EXHIBIT 5 - STAFF REPORT

DATE: November 2, 2023
TO: Planning Commission Members
FROM: Tom Schauer, Senior Planner
SUBJECT: Public Hearing – Planned Development Amendment PDA 5-23, Three Mile Lane Review TML 4-23, Landscape Plan Review L 38-23, Variance 3-23

DECISION, CONDITIONS, FINDINGS OF FACT AND CONCLUSIONARY FINDINGS FOR THE APPROVAL OF A PLANNED DEVELOPMENT AMENDMENT, THREE MILE LANE REVIEW, LANDSCAPE PLAN REVIEW, AND VARIANCE FOR PROPERTY AT THE SOUTH END OF SE NORTON LANE ON THE WEST SIDE, TAX LOT R4427 00701

DOCKET: PDA 5-23 (Planned Development Amendment)
TML 4-23 (Three Mile Lane Review)
L 38-23 (Landscape Plan Review)
VR 3-23 (Variance)

Figure 3a. Proposed Master Plan – Site Plan

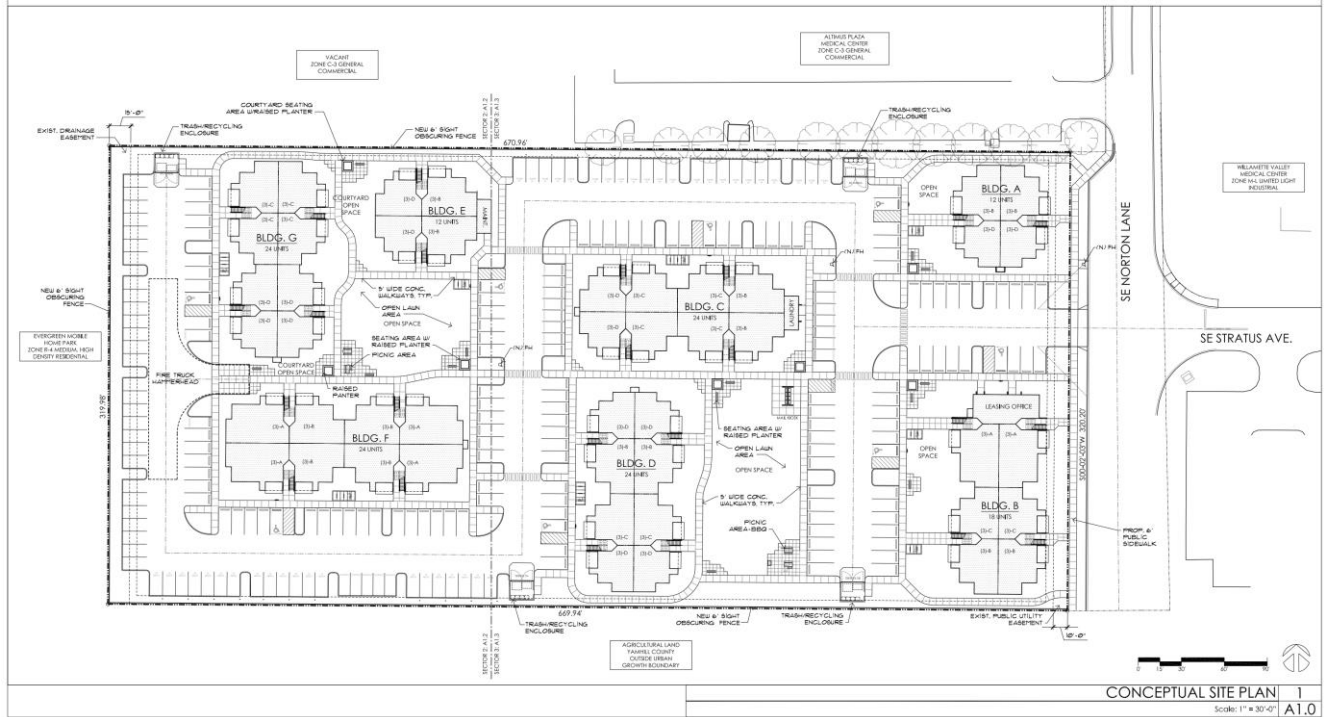
Note: This aerial/site plan is to show surrounding context only. The site plan has had minor changes not reflected below such as the 10' setback to the west:

2. The applicant shall submit a revised site plan that addresses the following:
 - a. Revise the site plan to achieve 65% minimum standard parking spaces at 9'x19'. Several of the spaces counted as standard spaces in the calculations are shown on the site plan as 17 feet deep. Alternatively, provide a calculation and request Planning Commission approval of a plan that has less than 65% standard spaces.

Landscape Plan - West Side

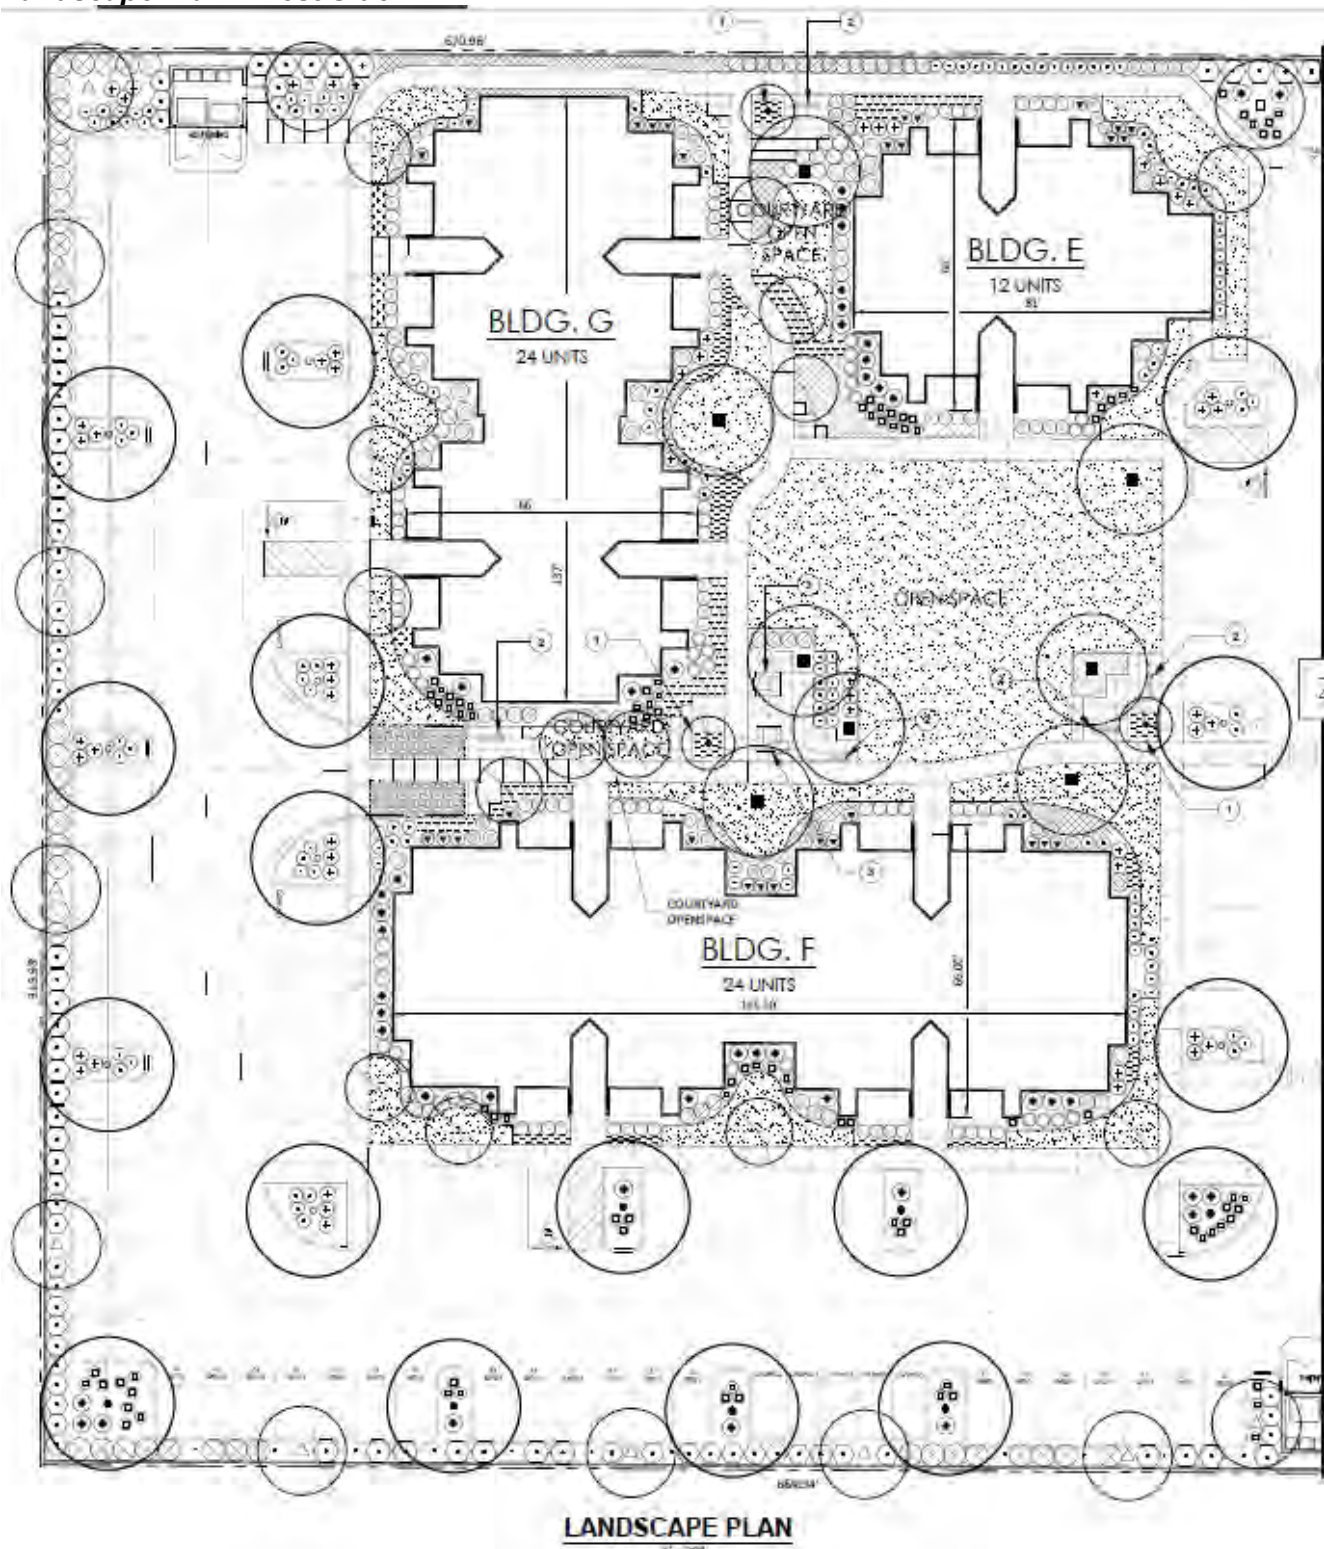
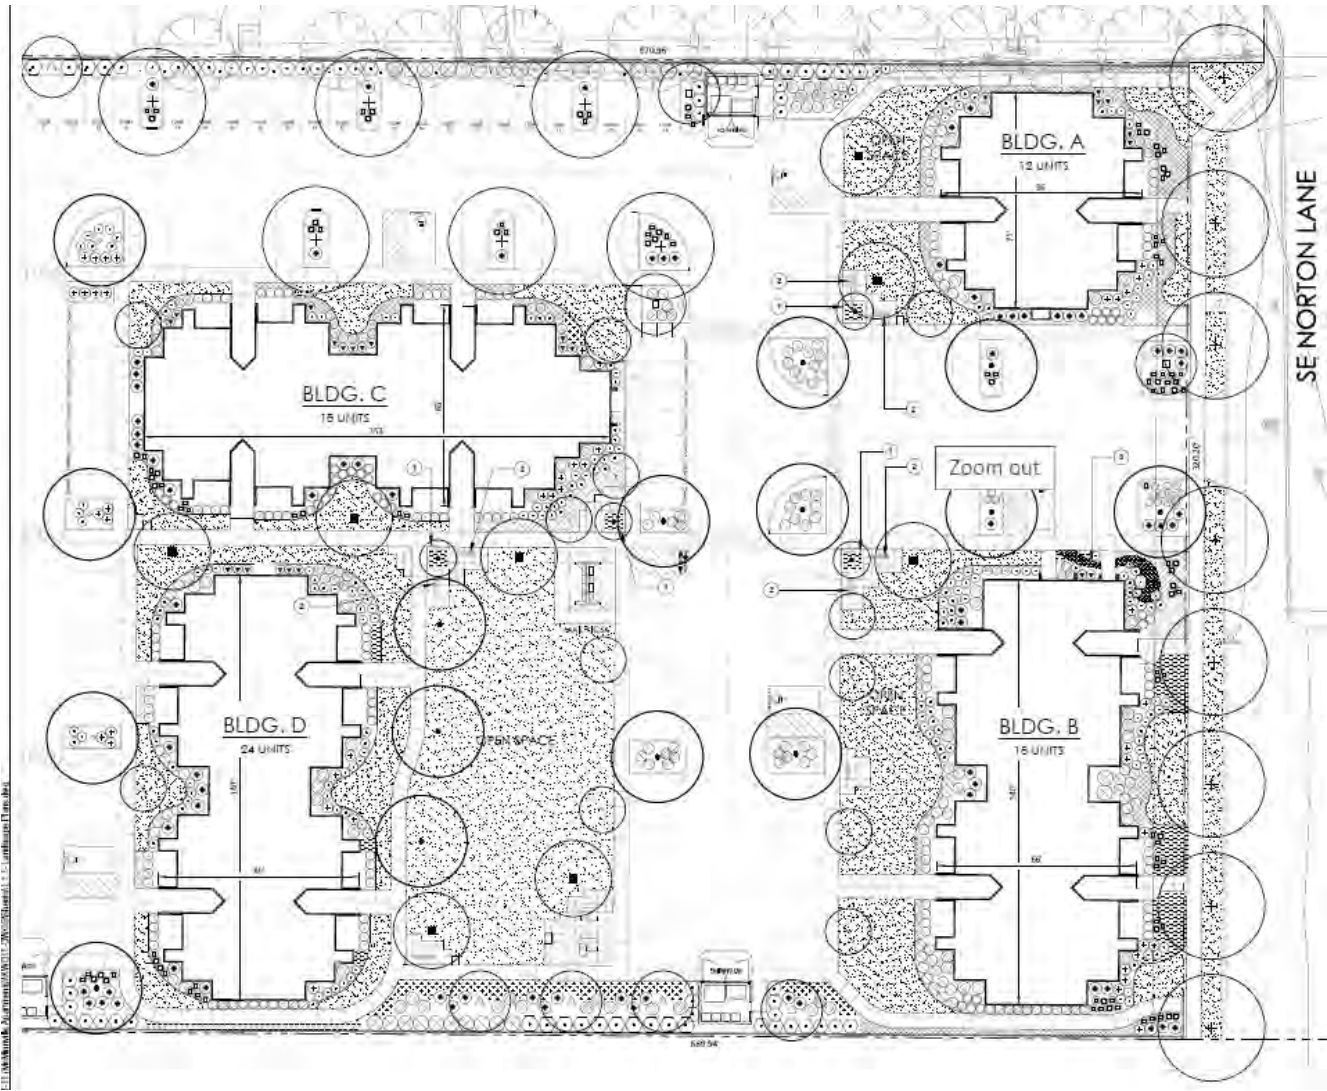
Landscape Plan: Note the landscape plan hasn't been updated to match the revised site plan which has a 10-foot setback on the west property line. (See applications for detailed plans and plant list.

2. The applicant shall submit a revised landscape plan addressing the following:
 - a. The landscape plan shall be revised to be consistent with the approved site plan, including the wider 10-foot landscape area along the west property line.

- b. Revise the proposed design of the frontage for the design of the planter strip to be consistent with McMinnville standards, with a standard rather than recessed planter strip that allows for installation of street trees.

- c. Revise the planting at the south side of the open space area between buildings B and D to incorporate landscaping influenced by agricultural themes consistent with policies 15 and 16 of the Three Mile Lane Area Plan. It is recommended that area or other are also incorporate food cultivation to meet 17.11.110.4.e. Otherwise, demonstrate which four items in 17.11.110.4 are being addressed.

Figure 4. Typical Elevations (Building E is similar to Building A shown below; Buildings C, D, F, G are similar to Building B shown below). Please see applications for full set of drawings – floorplans and elevations.

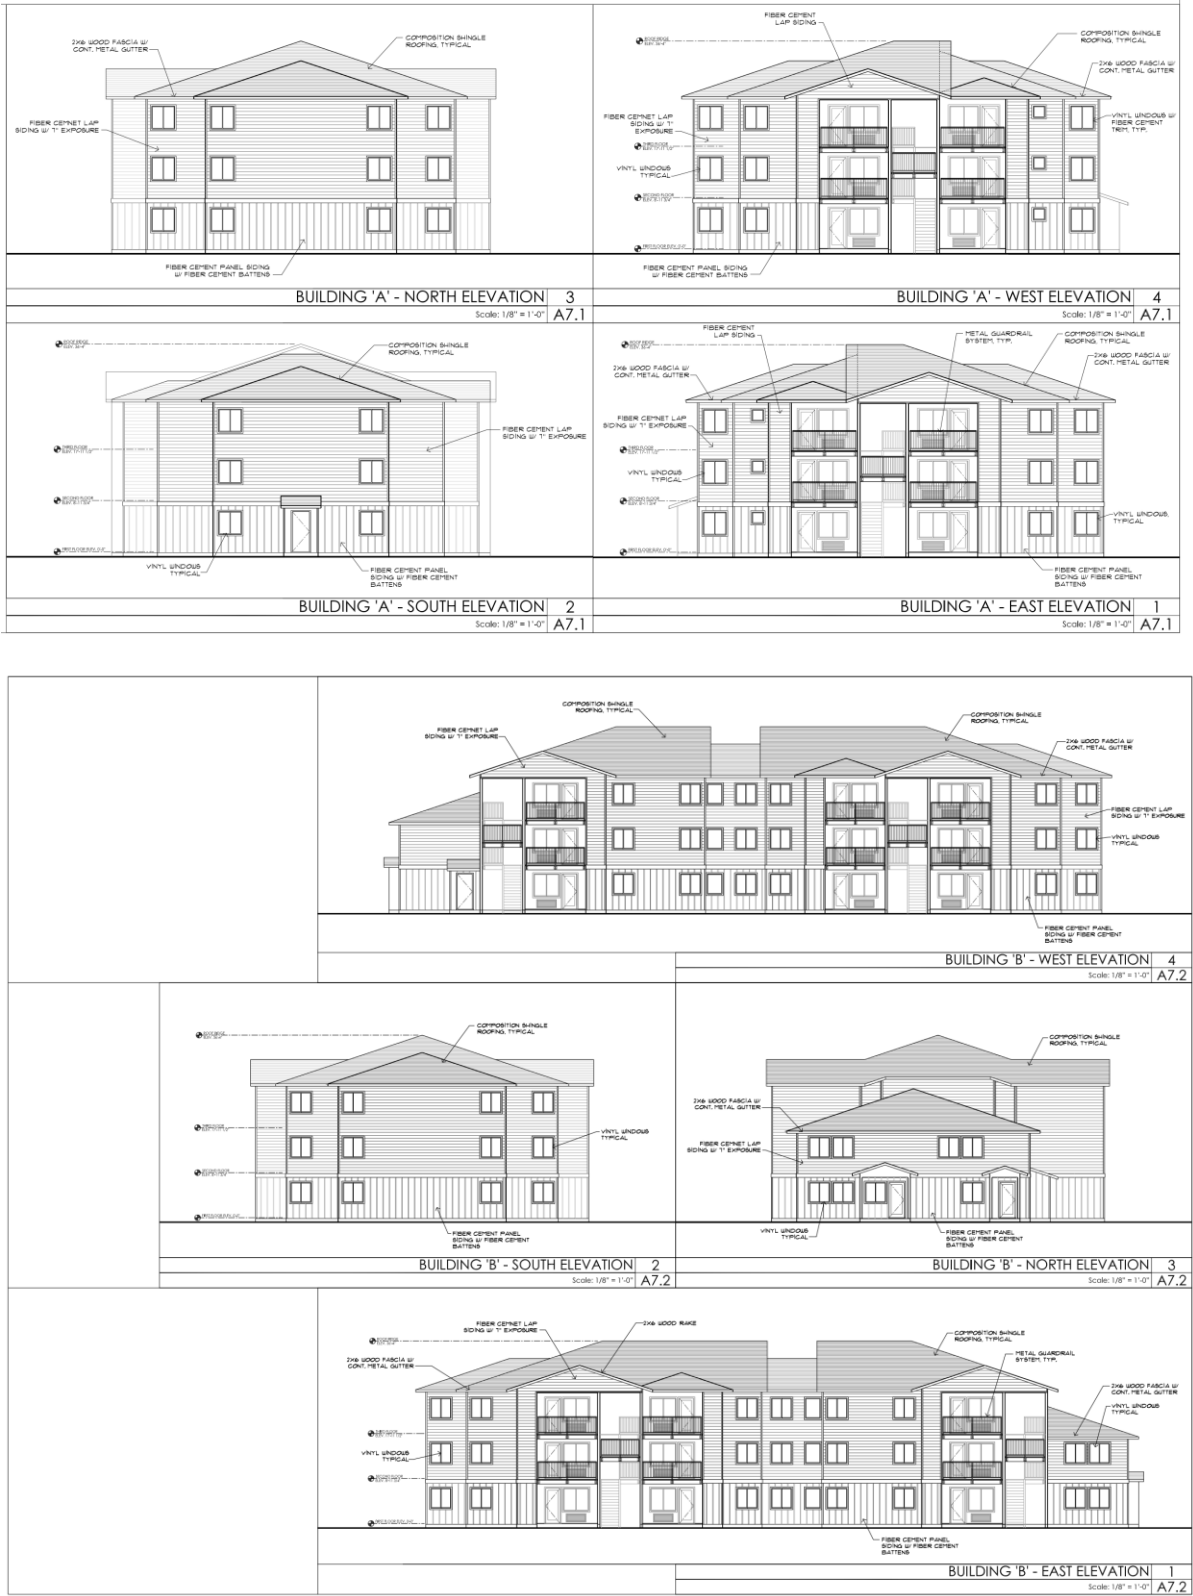
- Request to exceed 35' height limit of PD ordinance to allow height of highest ridge to 37'.

1. The variance to the 35' height limit in Ordinance 4709 is approved for a maximum of 37' to the buildings as proposed. The variances are specific to the approved plan for PDA 5-23, incorporating any revisions and conditions of approval. Any major changes to the plan shall require reconsideration of the variances.
2. Approval of the requested flexibility to the standards in Chapter 17.11 is based on the proposed plan. Any major changes to the plan shall require reconsideration of the approved reductions.
